Wollongong Local Planning Panel Assessment Report | 29 March 2022

WLPP No.	Item No.2
DA No.	DA -2021/901
Proposal	Mixed Use development - demolition of existing structures and construction of a 15 storey building comprising ground floor commercial/retail, residential shop top housing and associated parking
Property	2-8 Belmore Street WOLLONGONG
Applicant	ADM Architects
Responsible Team	Development Assessment and Certification - City Centre Major Development Team (BH)
Prior WLPP meeting	NA

ASSESSMENT REPORT AND RECOMMENDATION

Figure 5: Proposed section showing 48m height limit with lift over run dashed (*Source: ADM)

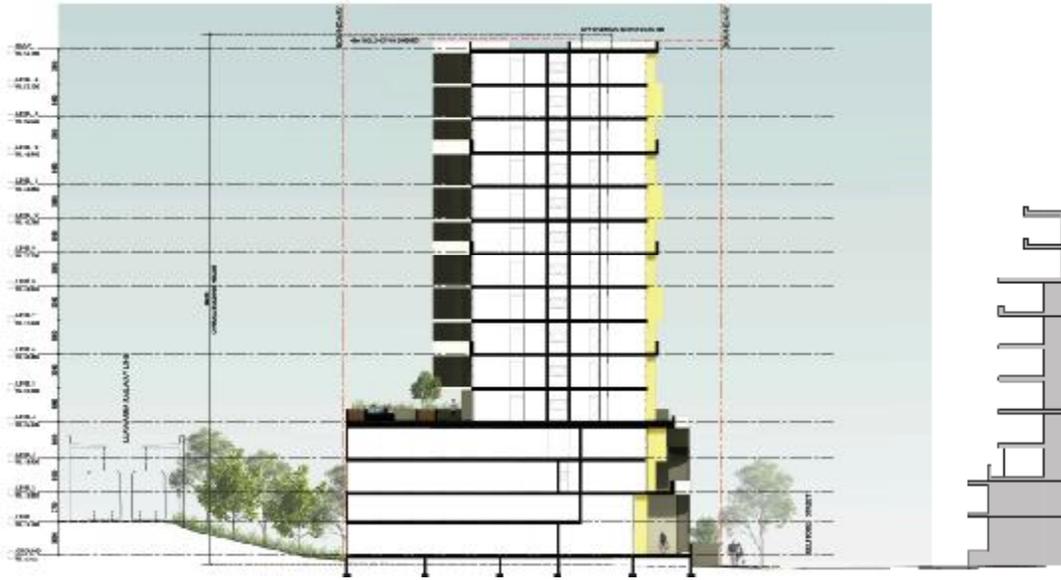
The maximum height is illustrated in the section prepared by ADM (see Figure 5). As shown, the extent of the variation relates to the solar panels and lift over-run and represents a small footprint at this height.
